Attachment I

Responses-to-Comments Table

S.12A Application for Amendment of Plan To Rezone the Application Site from “Green Belt” and “Village Type Development” to “Residential (Group B)13” and Amend the Notes of the Zone Applicable
(Application No. Y/TP/42)

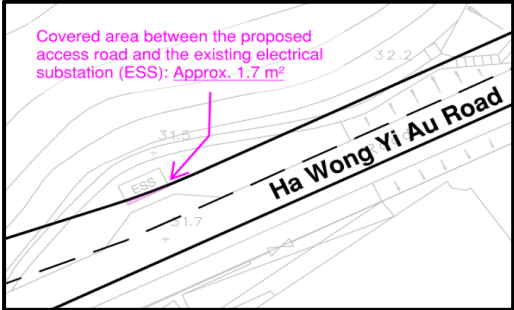
No.	Comments	Responses
	4. Table 6.5: Please check the values for annual FSP. 5. Figure 6.3a-6.3b, RtC#6: – It is observed that there may be devices providing mechanical ventilation at the corner of Ling Liang Church M H Lau Secondary School. Please clarify whether those devices have been considered. – In view of the tight margin for fulfillment of the HKPSG, please carefully indicate the 5 m buffer and avoid encroaching into the carriageway. – Please remove any unnecessary ghost lines and shadows in the figure to clearly demonstrate that the HKPSG’s buffer distance requirements are fulfilled. <u>Water Quality</u> 1. Section 9.6.3.1: – Please clarify the sentence “on-site sewage treatment facilities are proposed to treat greywater and blackwater that will be discharge to the TPKSPS”. From S.3.5.1.3 of the SIA, on-site sewage treatment facilities are proposed to treat greywater and blackwater will be discharge to the TPKSPS. – Please also clarify in this paragraph how the treated effluent from the on-site sewage treatment facilities will be handled. From S.3.5.1.3 of the SIA, it appears that the treated effluent will be discharged to nearby watercourses. – Suggest also mentioning in this paragraph that a licence granted under the Water Pollution Control Ordinance should be obtained for the discharge of on-site sewage treatment facilities, and the discharge of the treated effluent shall comply with the requirements of the	Updated accordingly. Considering there may be devices providing mechanical ventilation at the corner of the school, the measurement points have been updated in Figure 6.3a of revised EA (Appendix C), with an inset for clarity. Noted and Figures 6.3a and 6.3b of the revised EA (Appendix C) have been updated. Noted and Figures 6.3a and 6.3b of the revised EA (Appendix C) have been updated. S.9.6.3.1 of the revised EA (Appendix C) and Para. 3.5.1.3 of the revised Sewerage Impact Assessment (SIA) report (Appendix D) have been revised for clarity. S.9.6.3.1 of the revised EA (Appendix C) and Para. 3.5.1.3 of the revised SIA report (Appendix D) have been revised for clarity. Supplemented accordingly.
